# Access Compliance Report

## Public Rights-of-Way

Intersection ID: 17886	Main Street: PROVIDENCE_RD	Cross Street: VERNON_DR	Location: NE
ADA ID: B3DF3E84B8DD	Ramp Type: PerpDiag	Initial Pass/Fail: Fail	Overall Compliance: No
		Severity Score: 35

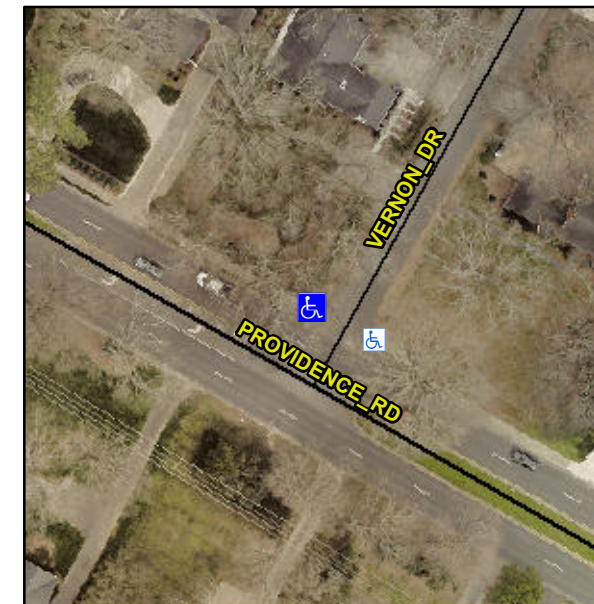
**Not Found, R304.5.1**

Compliance	Description	Data	Compliance	Description	Data
N/A	Ramp Length (in)	57.0	Yes	Ramp Slope (%)	6.6
No	Ramp Width (in)	30.5	Yes	Ramp XSlope (%)	0.0
N/A	Flare Type LT	N/A	N/A	Flare Type RT	N/A
N/A	Flare Slope LT (%)	N/A	N/A	Flare Slope RT (%)	N/A
N/A	Flare Traversable LT?	N/A	N/A	Flare Traversable RT?	N/A
N/A	Landing Length (in)	N/A	N/A	DWS Provided?	N/A
N/A	Landing Width (in)	N/A	N/A	DWS Contrast?	N/A
N/A	Landing Slope (%)	N/A	N/A	DWS Length (in)	N/A
N/A	Landing X Slope (%)	N/A	N/A	DWS Full Width?	N/A
N/A	Landing Curb? (Y/N)	N/A	N/A	DWS Offset (in)	N/A
N/A	Shared Landing?	N/A			
N/A	Gutter Ponding?	N/A	N/A	Gutter Slope (%)	N/A
N/A	Gutter Lip Ht (in)	N/A	N/A	Gutter X Slope (%)	N/A
N/A	Painted X Walk1?	No	N/A	Painted X Walk2?	No
	X Walk 1 Direction	To SW		X Walk 2 Direction	To SE
N/A	X Walk 1 Width (in)	N/A	N/A	X Walk 2 Width (in)	N/A
	X Walk 1 Slope (%)	5.3		X Walk 2 Slope (%)	1.4
	X Walk 1 X Slope (%)	5.7		X Walk 2 X Slope (%)	6.3

**Remove & Replace Curb Ramp With Two New Directional Ramps or Equivalent.**
